TYPE 187 TELEPHONE SET
TWO-WIRE TO FOUR-WIRE MODIFICATION

1.02   This section is reissued to incorporate a two-wire to four-wire modification for any individual pickup line. Marginal arrows are used to identify the new material. Remove the previous issue of this section from the binder or microfiche file and replace it with this issue.

Figure 1. Modification for Two-Wire to Four-Wire Service (Three Lines).

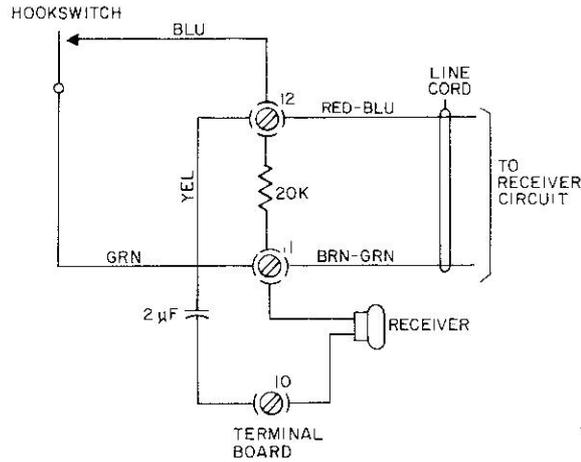
(a)   Move the blue hookswitch lead from terminal board terminal L2 to terminal board terminal 12.
(b)   Move the green hookswitch lead from transmission network terminal 13 to terminal board terminal 11.
(c)   Remove the yellow strap between terminal board terminal 10 and transmission network terminal 4.
(d)   Remove the black strap between terminal board terminal 11 and transmission network terminal 23.
(e)   Add the resistor between terminal board terminal 11 and terminal board terminal 12.
(f)   Add the capacitor between terminal board terminal 10 and terminal board terminal 12.
(g)   Move the red-blue line cord lead from terminal board terminal 7 to terminal board terminal 12.
(h)   Move the brown-green line cord lead from terminal board terminal S to terminal board terminal 11.
(i)   Replace the receive capsule (D-51030-A) with the high impedance receiver capsule (D-51033-A).

2.03   This modification sets up all three lines for four-wire service since the receiver leads remain on terminal board terminal 10 and 11.

Figure 2. Modification for Two-Wire to Four-Wire Service (One Line).

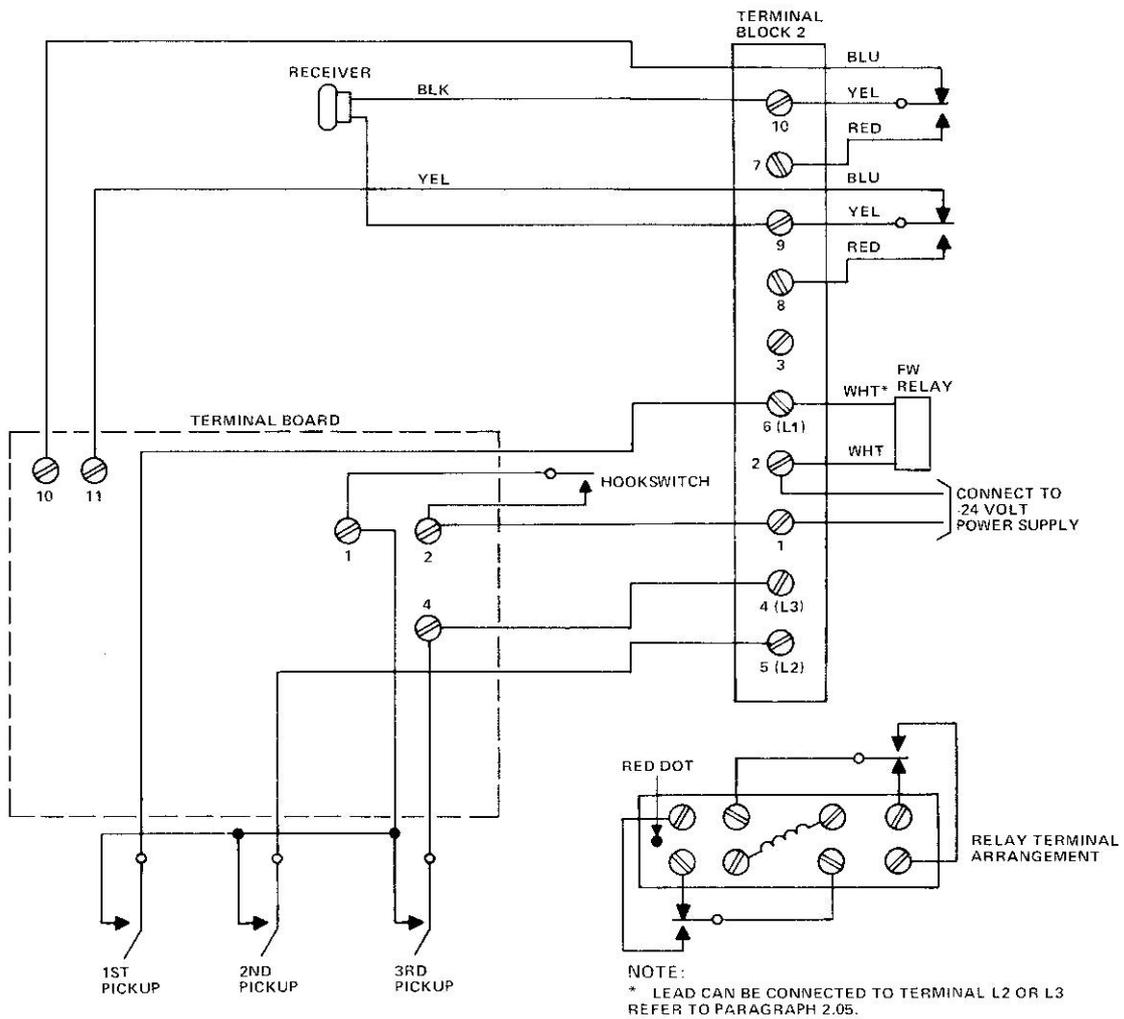
2.04   To provide two-wire to four-wire service on any one of the three available pickup keys, an H-888578-1 modification kit is used. This kit consists of a small enclosed relay (FW) and hardware. This kit is used with an external 24-Vdc power supply (Figure 2). A dial or Touch Calling Unit (TCU) version Type 187 telephone set can be modified to provide two-wire to four-wire service. When operated the FW relay transfers the handset receiver connection from the two-wire network to separate pairs. The busy lamp contacts of the pickup selected for four-wire operation are used to operate the FW relay when it is connected to the telephone set. The external power supply provides voltage to the FW relay and to light the busy lamp.

(a)   Remove the yellow receiver lead from terminal board terminal 11 and connect it to terminal 9 of terminal block 2.
(b)   Remove the black receiver lead from terminal board terminal 10 and connect it to terminal 10 of terminal block 2.
(c)   Connect one of the white FW relay leads to terminal 1 of terminal block 2; connect the other white FW relay lead to one of the following lamp lead terminals:

(1)   If the first pickup key is used, use terminal 6.
(2)   If the second pickup key is used, use terminal 5.
(3)   If the third pickup key is used, use terminal 4.

(d)   Connect the yellow FW relay leads to terminals 6 and 9 of terminal block 2.
(e)   Connect the red FW relay leads to terminals 7 and 8 of terminal block 2.
(f)   Connect the blue FW relay leads to terminals 10 and 11 of the terminal board.
(g)   Mount the FW relay on the right leg of the dial or TCU mounting bracket by using the lockwasher and hex nut provided in the kit.
